WEST LEECHBURG RESERVOIR DAM

**PHASE I INSPECTION REPORT
NATIONAL DAM INSPECTION PROGRAM**

DEPARTMENT OF THE ARMY
Baltimore District, Corps of Engineers
Baltimore, Maryland 21203

GAI CONSULTANTS, INC.
570 BEATTY ROAD
MONROEVILLE, PENNSYLVANIA 15146
OCTOBER 1978

FIGURE 2 CONTRACT NO. 1

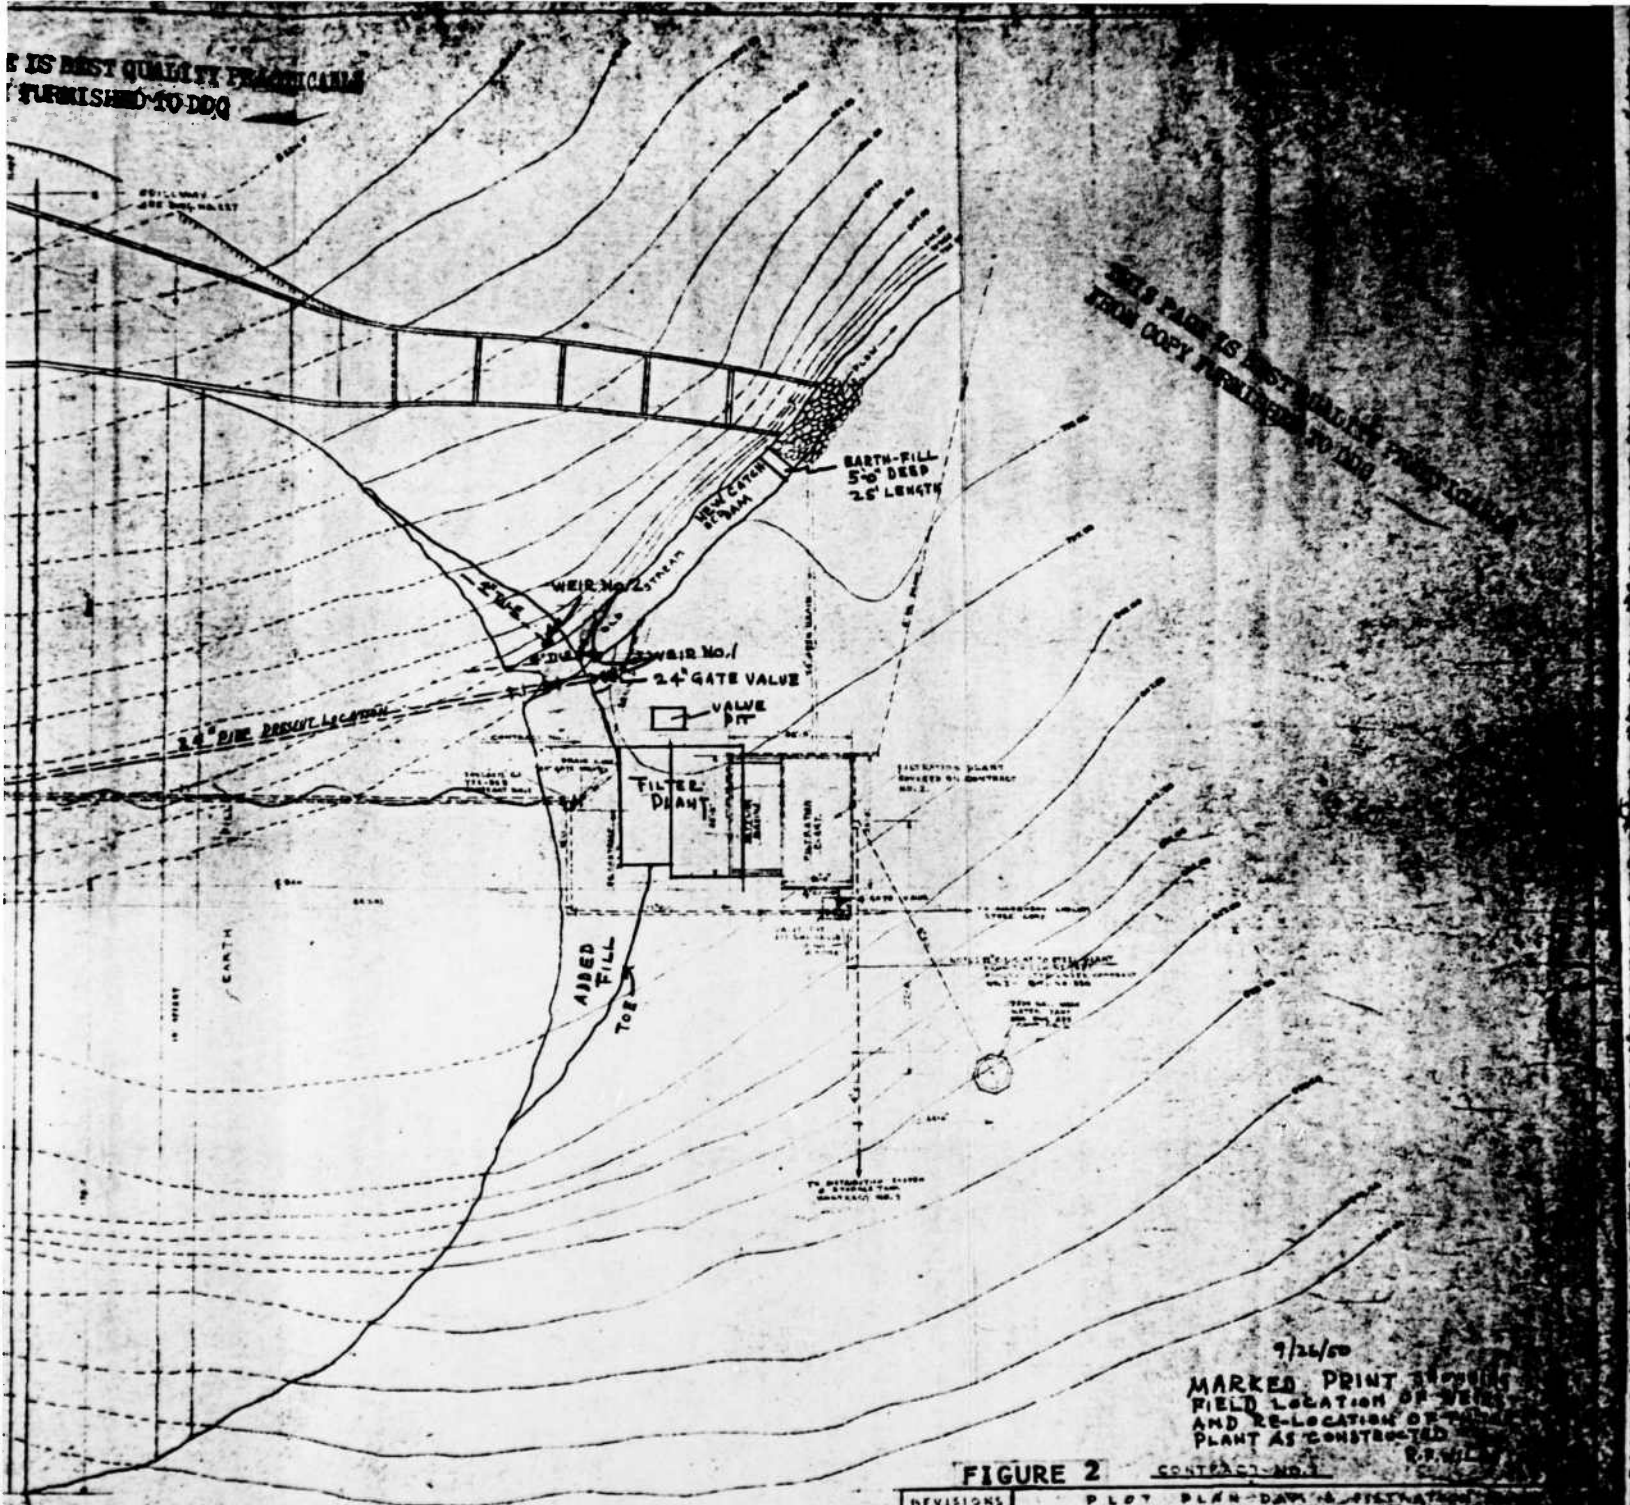
Seepage also discharges through a four-inch tile drain in the old stream channel to the left of the treatment facility. Two tile drains are shown on Figure 2 and are referred to in PennDER reports. The owner claimed that this seepage passes through the left abutment and issues from a spring that was located prior to, or during construction.

Tile drains observed adjacent to the discharge of the blow-off conduit located approximately 25 feet to the left of the treatment facility at the toe of the embankment. The location of the drain lines are shown on design drawings (see Figure 2, Appendix F).

FIGURE 4

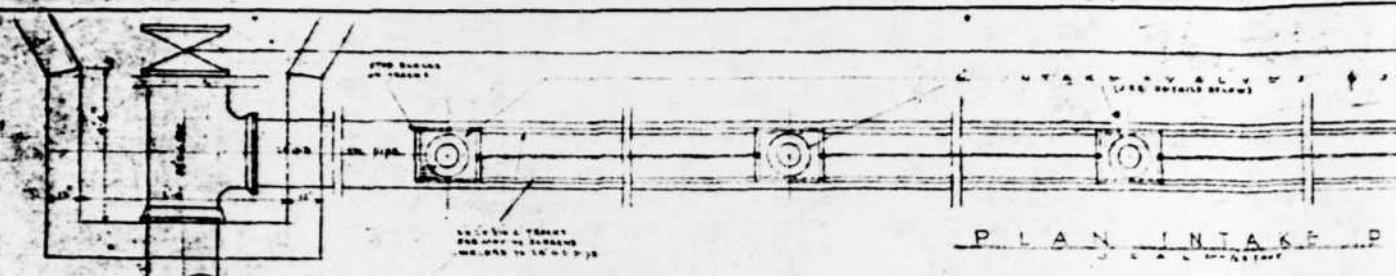
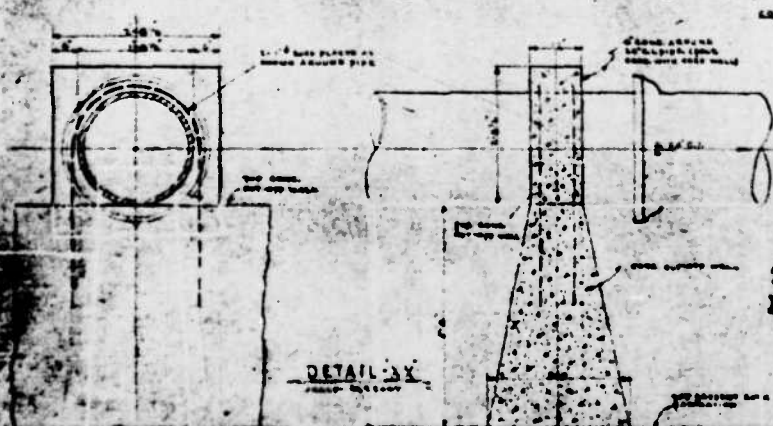
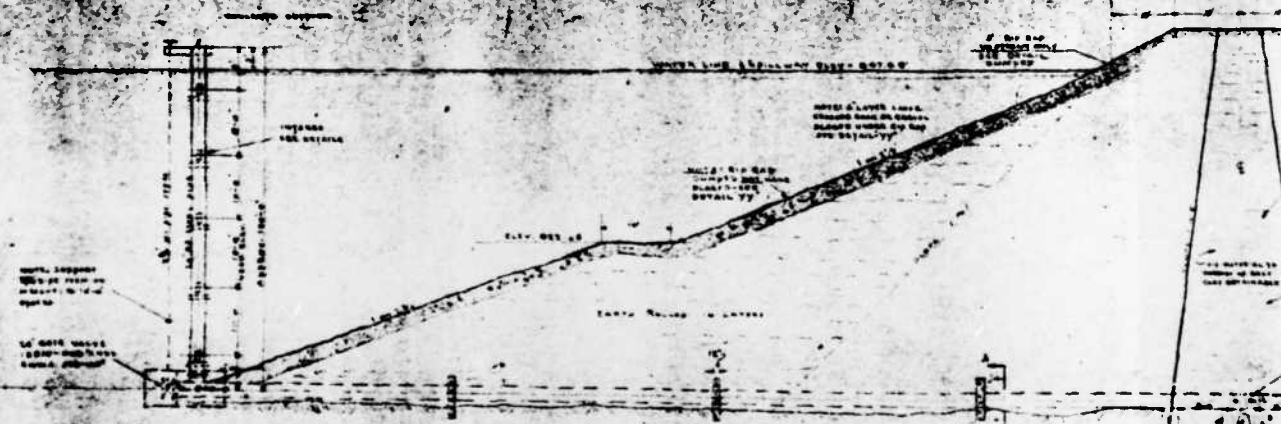
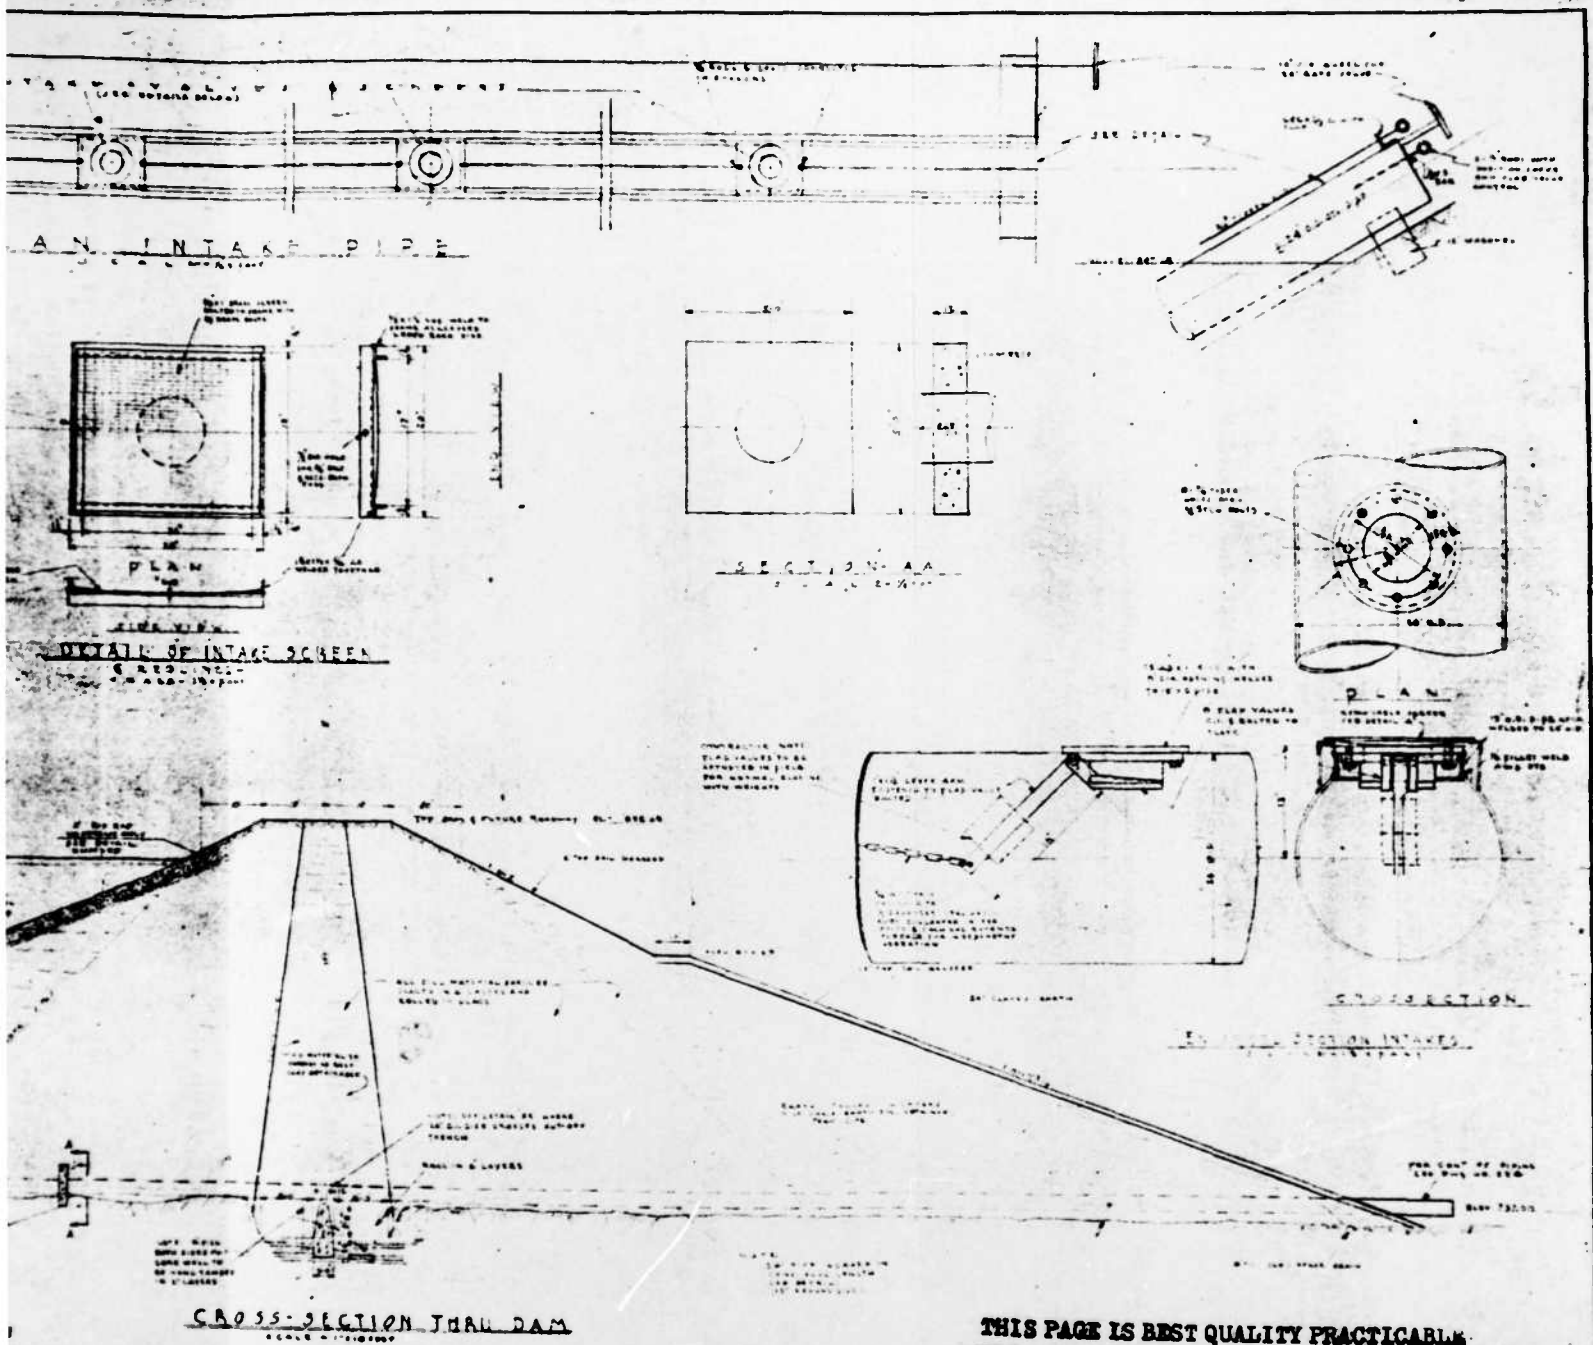
inlet end of the system (as shown on Figure 4) was provided with a tee. The straight section of the tee is valved whereas the section at right angles was provided with a 24-inch steel riser pipe that rested on the left abutment and protruded from the water at a point above 175 feet upstream of the dam centerline. The riser pipe was equipped with five openings, thus allowing the water authority to decant water from several elevations within the reservoir. The gate controls for these openings are presently open and are no longer functioning. Thus, flow through the 24-inch outlet pipe cannot be controlled at the inlet end.

The outlet works at the facility consist of a tee connection on a 24-inch cast iron pipe, encased in concrete beneath the embankment (see Figure 4). The straight section of the tee is gated at the inlet end and rests on the bottom of the reservoir acting as a blow-off. The 90°-section of the tee is connected to a riser pipe containing five gated portal openings at different elevations within the reservoir. This riser pipe protrudes from the reservoir upstream of the spillway along the left bank of the reservoir (see Photographs 1, 4, and 8). Controls for both the gate valve on the blow-off pipe and slide gates on the riser pipe, were operated from this point. According to water company personnel, none of these controls are now functional and all riser gates are thought to be open.

- c. Modify or repair the outlet system so as to provide a method for controlling discharge at the inlet end of the 24-inch diameter outlet pipe.
